Attachment A

Revision to Section 5.0

Seabrook Station Radiological Emergency Plan

FIGURE 5.6

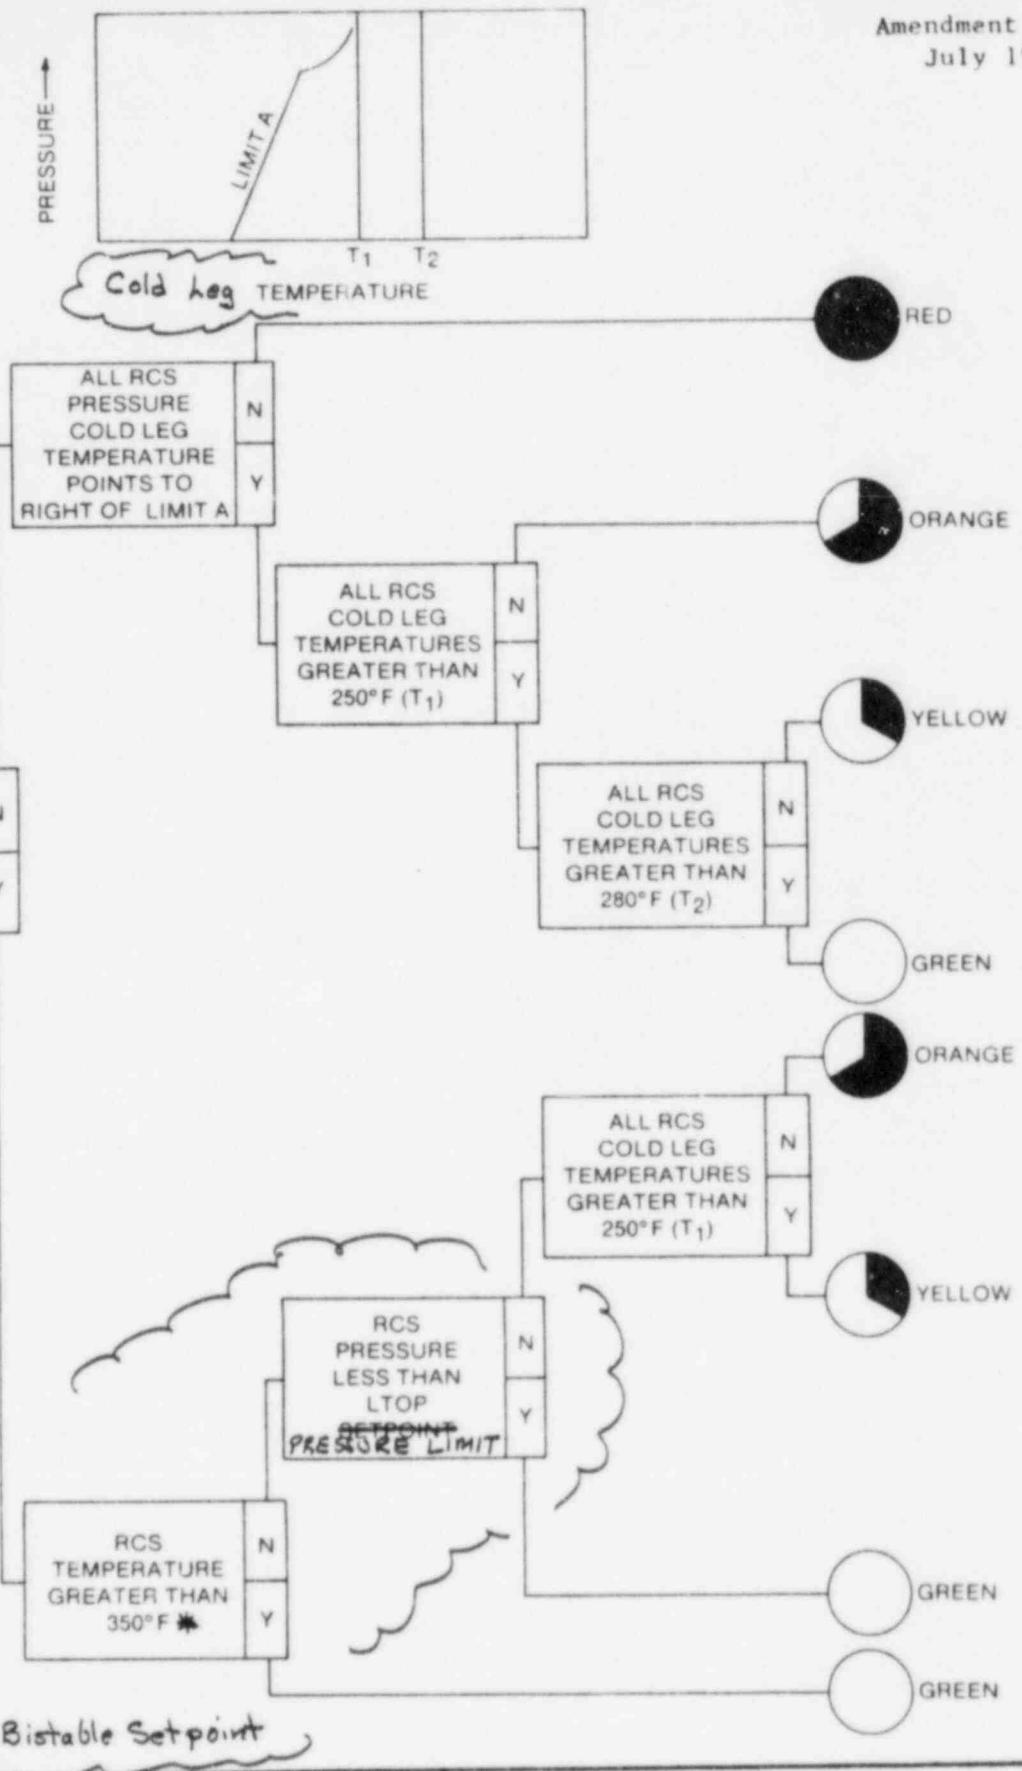
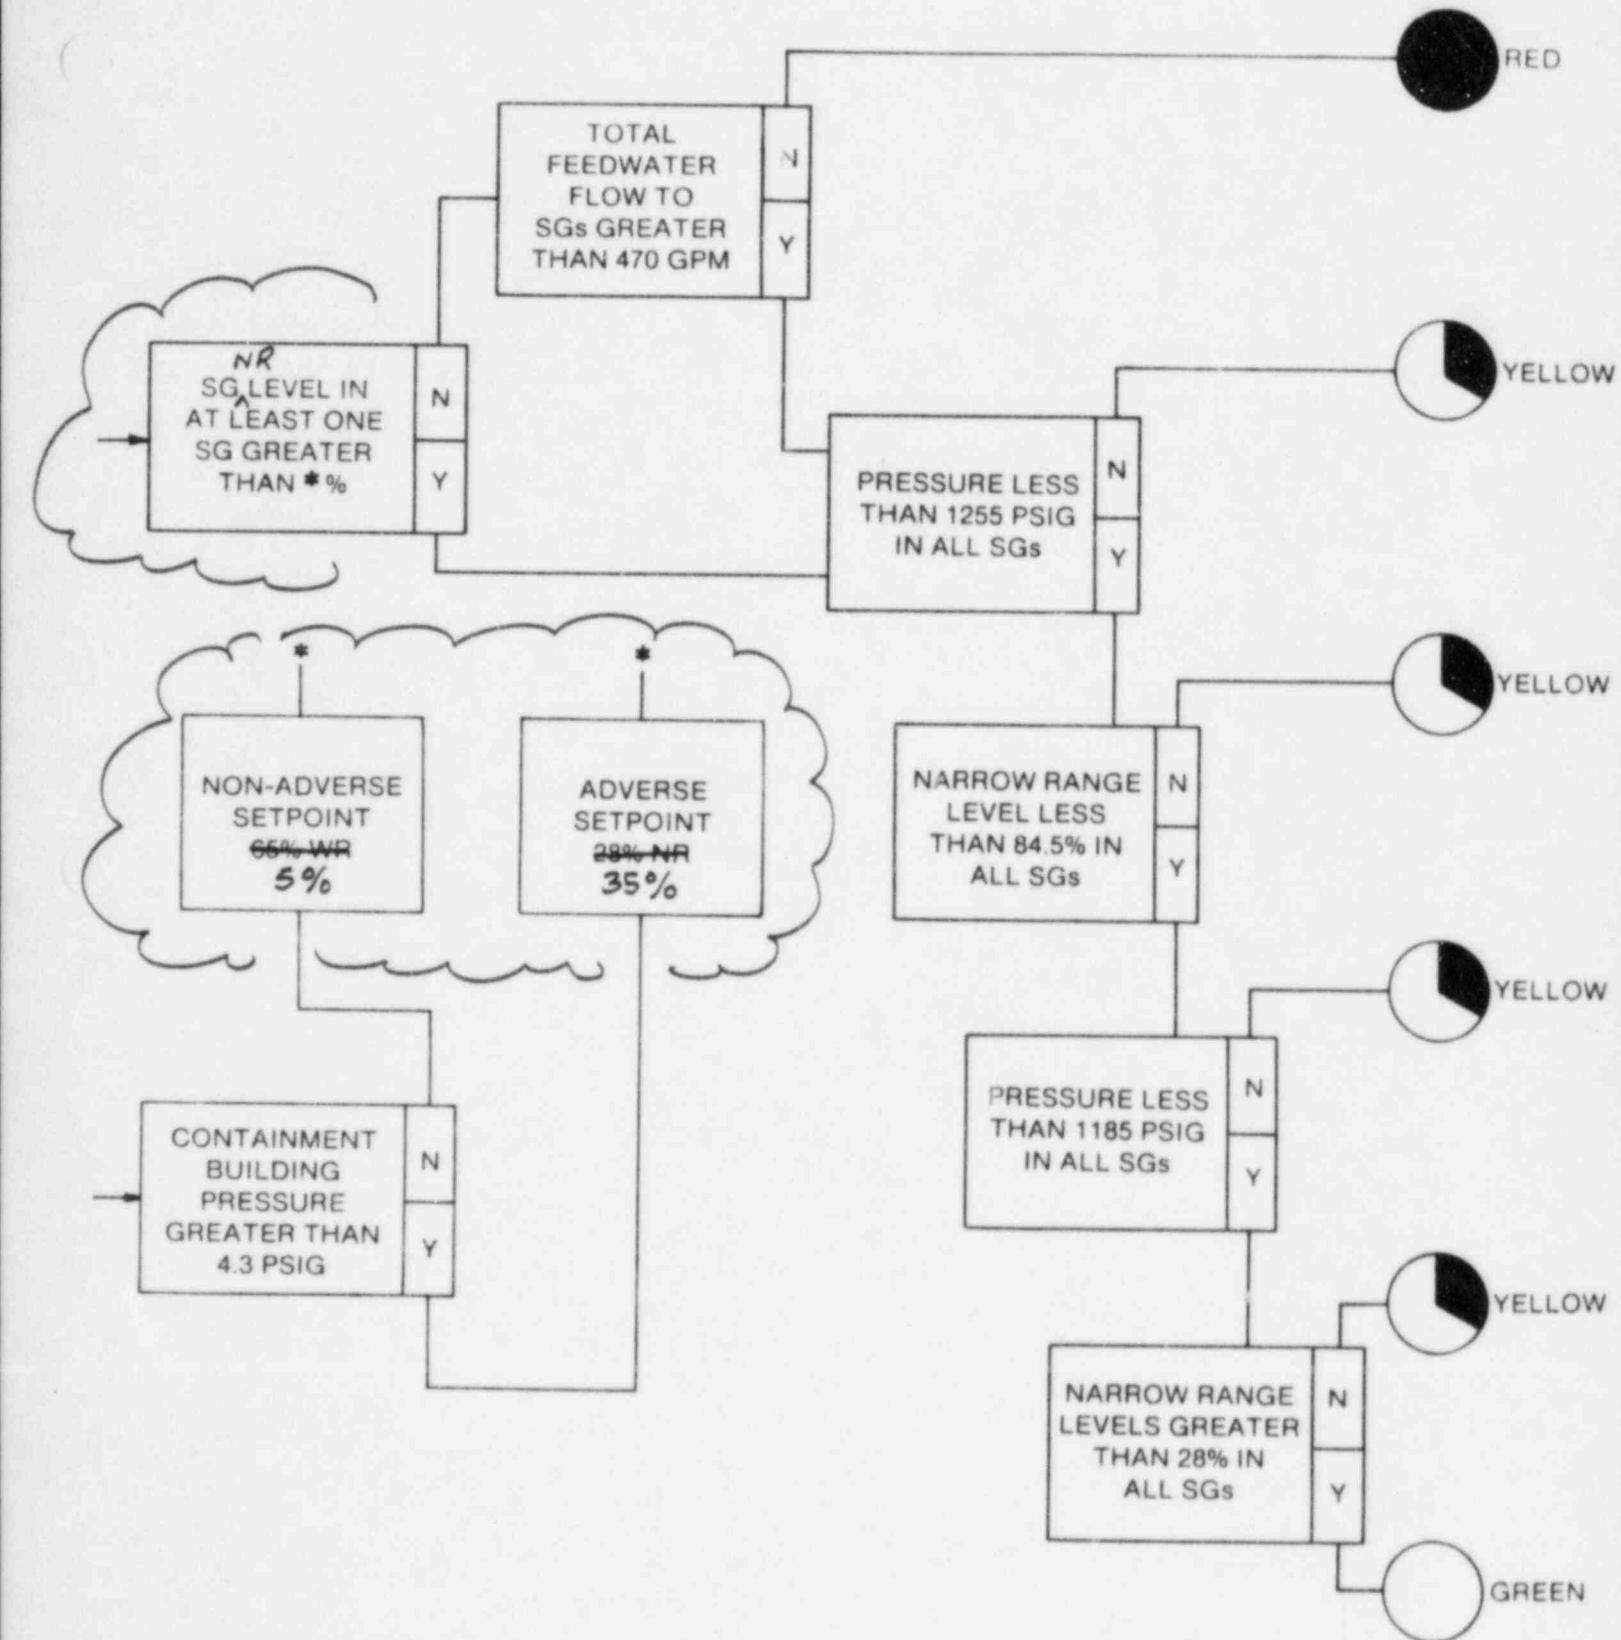
Insert "A"

Classification of an emergency at Seabrook Station is made based on one or more of the conditions listed in Figure 5.6. Specific EAL's (color status trees, meter indications, alarms, or limits) for initiating conditions are provided in an emergency response procedure and in operator training. In all cases, if several emergency classifications are indicated, the most severe emergency classification will be made whether based upon status trees or miscellaneous initiating conditions.

Insert "A"

onto p. 5-3

The specific emergency response procedure is ER-1.1 "Classification of Emergencies". This procedure contains the specific EAL's that serve as the basis for an emergency condition classification into one of the four emergency categories. This includes specific definitions of the events (i.e. natural phenomena, man-made occurrences, security threats and discretionary items) under category 18 of Figure 5.6.

Item 14b of the Seabrook Station classification system requires the operator to verify that any ECCS activation event is not inadvertent. Verified and validated emergency response procedures E.O. and ES-1.1 provide positive assurance that any such actuation has not been initiated due to an actual condition. If such actuation is in response to an actual event or, if conditions allowing termination cannot be achieved, then the declaration of an Unusual Event is required by procedure ER-1.1.

Item 15b of the Seabrook Station classification system conservatively satisfies a loss of coolant greater than makeup pump capacity. If leakage is greater than the capacity of one of two available makeup pumps, the operator is directed to trip the plant and initiate safety injection. These actions will result in entry into Procedure E-1, which constitutes a Site Area Emergency.

We have reviewed these examples against the events incorporated as General Emergencies in the Seabrook Station classification system and have concluded that the desire of early identification of these types of conditions is met with our classification system.
